**CITY OF LA VISTA  
MAYOR AND CITY COUNCIL REPORT  
AUGUST 7, 2007 AGENDA**

<b>Subject:</b>	<b>Type:</b>	<b>Submitted By:</b>
NINTH AMENDMENT TO SUBDIVISION AGREEMENT — SOUTHPORT EAST REPLAT NINE	◆ RESOLUTION ORDINANCE RECEIVE/FILE	ANN BIRCH COMMUNITY DEVELOPMENT DIRECTOR

RE: 2007 Minor & Administrative Plat Reviews  
Southport East Replat Nine  
Review of Initial Submittal  
TD<sup>2</sup> File No. 171-344

RE: Proposed PUD Plan  
Lots 1-4, Southport East Replat Nine  
Initial Review  
TD<sup>2</sup> File No. 171-345

## EXHIBIT "E"

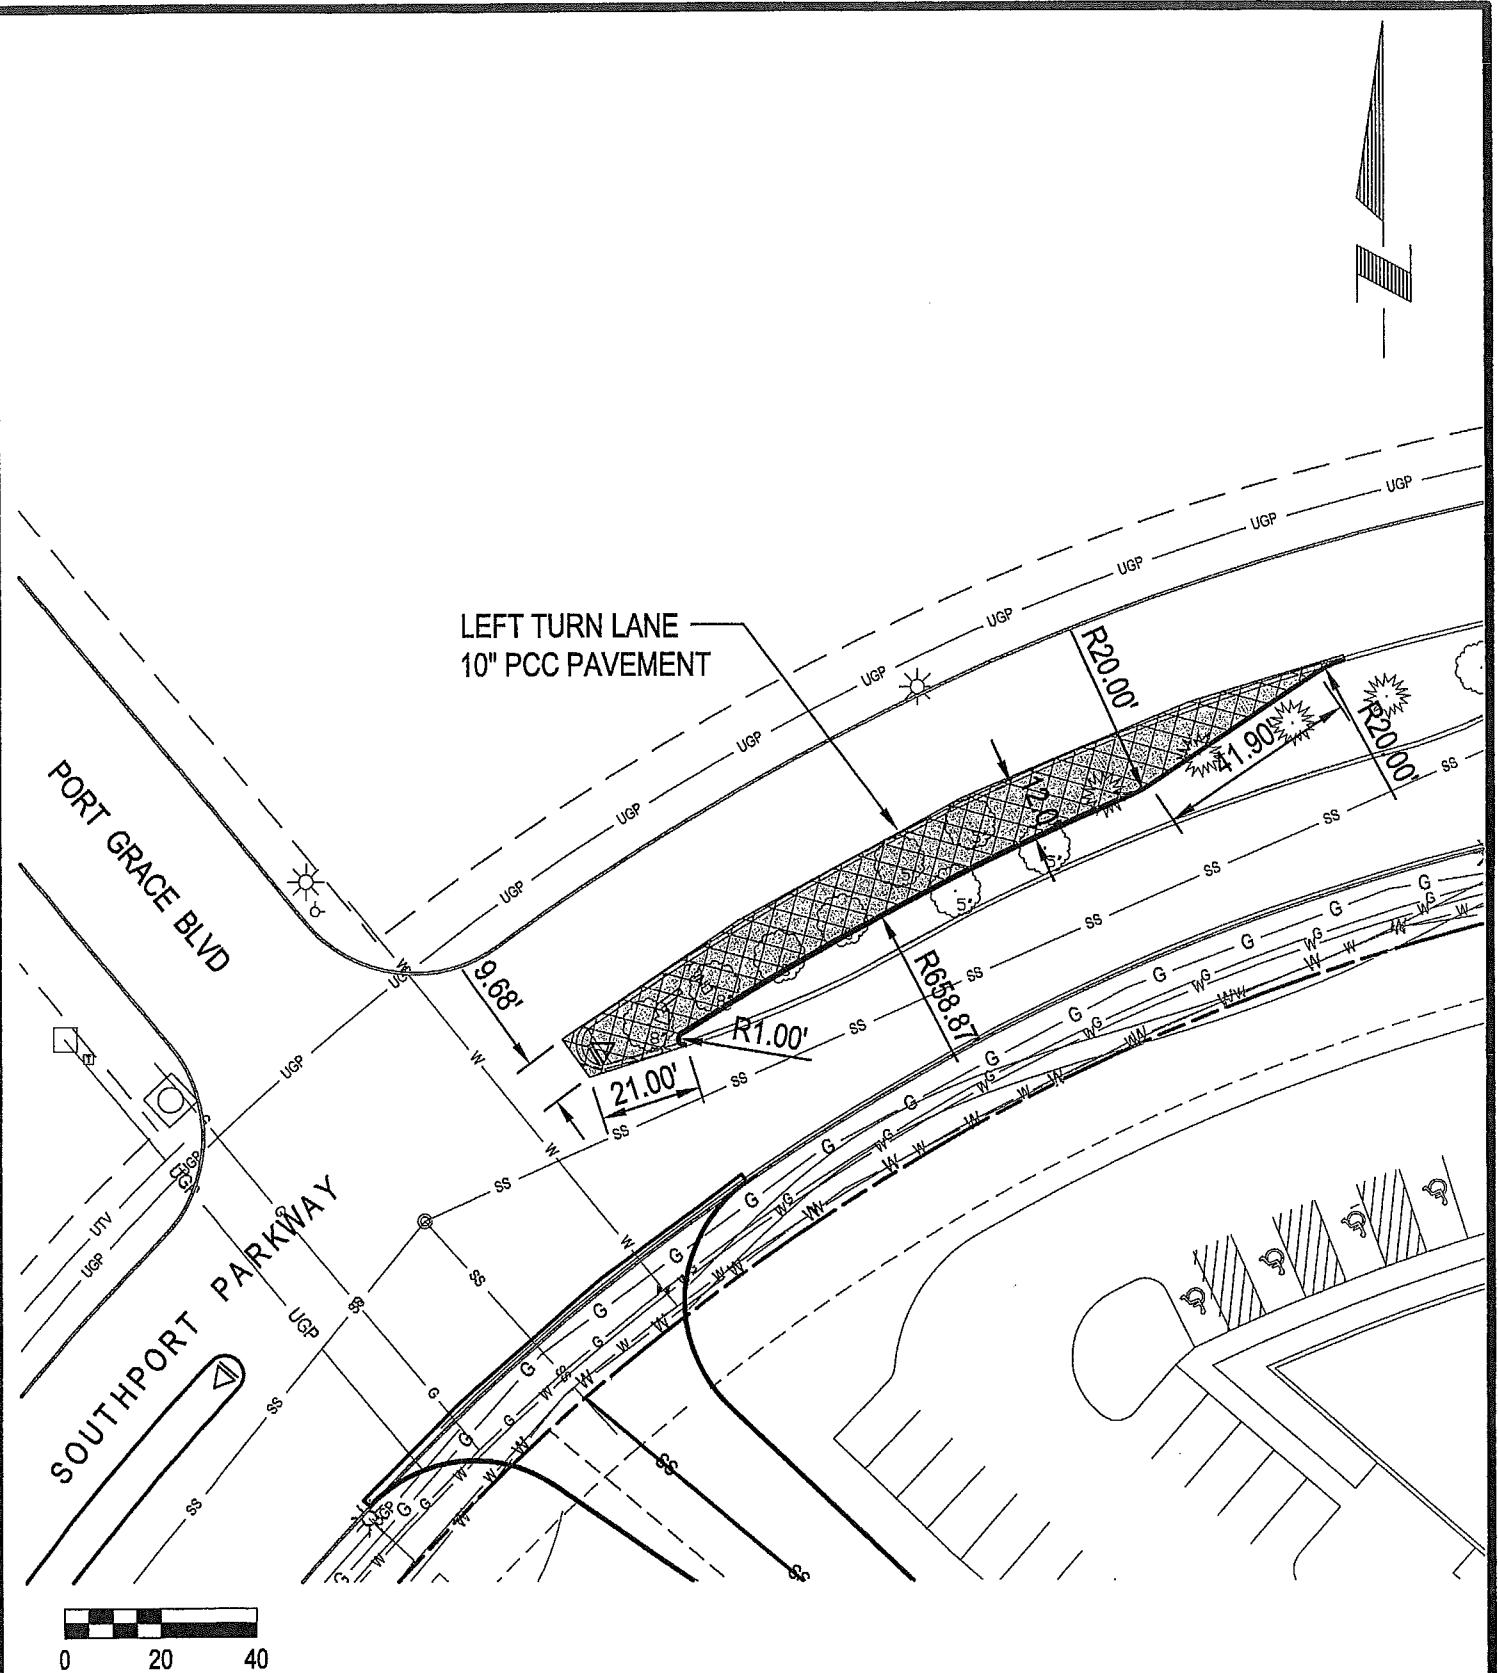
8. There will need to be an amendment to the common area maintenance agreement prepared for Replat Six to reallocate costs of construction and maintenance due to the revised configuration of lots.

12. Common Improvements/Maintenance. For purposes hereof, the following provisions shall be applicable:
  - a. Common Area Improvement Defined. The term Common Area Improvement shall mean all infrastructure and improvements set forth on Exhibit "E". Said Common Area Improvements shall include, but not be limited to, ingress and egress, roads, parking, storm drainage, sanitary sewer, public utility infrastructure or services and other infrastructure needs for or benefiting more than a single lot. The Common Area Improvements are internal to the replat area and are shown on the attached Exhibit "E" incorporated herein by this reference.
